NOTICE OF SWIMMING POOL NON-COMPLIANCE
(Clause 22E, Swimming Pools Act 1992)

Premises to which this notice relates: 94 Bantry Bay Road Frenchs Forest.

Pool Installation Description: In-ground concrete swimming pool

(a) Boundary barrier 1800 mm min.

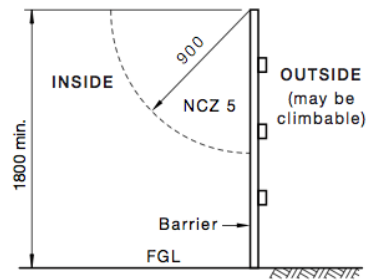
The boundary fence rails and timber and pot feature were located on the inside of the boundary fence that could be used as a foothold for children to climb down into the pool enclosure.

Shield the fence rails and remove the timber and pot feature from within the 900 mm Non-Climb Zone (NCZ 5). Alternatively, the boundary fence could be raised to achieve the required 900 mm Non-Climb Zone (NCZ 5) clearance from the object. The NCZ 5 is a 900 mm arc measured from the top of the fence and is quarter-circle in shape.

See diagram below for NCZ 5

(a) Boundary barrier 1800 mm min.

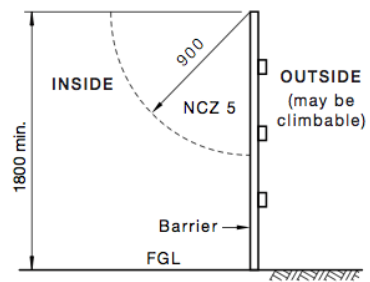
The effective height of the boundary fence was not 1800 mm or more. In some sections a garden bed had been built within 500 mm of the fence. The height of the fence was measured from the top of the fence to the surface of the ground or garden bed on the pool side of the fence. The fence also had climbable rails on the pool side of the fence.

Replace the boundary fence with a boundary fence that has a height greater than 1800 mm when measured to the surface of the deck, or alternatively;

Raise the fence so it is 1800 mm or more in height above the surface level of the ground/ garden bed; or

The garden bed could be lowered so that the effective height of the fence is 1800 mm; or

The portion of the deck within 500 mm of the fence could be removed so that the 1800 mm effective height of the fence can be measured to the ground and not onto the surface of the soil.

Boundary fences must be provided with a 900 mm Non-Climb Zone (NCZ 5) which is located at the top of the fence (on the pool side of the fence). The boundary fence must be provided with a 900 mm NCZ 5 and any fence extension construction provided on top of the existing fence or rails etc (that have footholds greater than 10 mm wide) must not be within the 900 mm NCZ 5. Any climbable fence component within the 900 mm NCZ 5 will need to be either lowered removed or shielded to ensure that children cannot use any climbable fence component to assist them to climb into the pool enclosure.

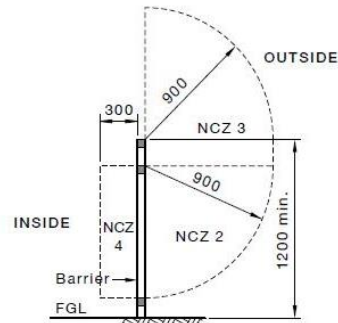
the rails on the new boundary fence near garage gate was within the 900 mm Non-Climb Zone (NCZ) on the outside of the pool fence. The 900 mm NCZ is required to be kept clear so that children cannot use any object close to the fence to assist them to climb into the pool enclosure. See diagram below for internal NCZ's

Remove or relocate or shield the rails on boundary fence near garage gate outside the 900 mm NCZ so it cannot be used to assist children to climb over the fence and into the pool enclosure. The NCZ is a 900 mm arc measured outward from the top most rail on the fence (if there is an upper rail) or the top of the fence and also extends upward above the top of the fence. The NCZ is semi-circular in shape.
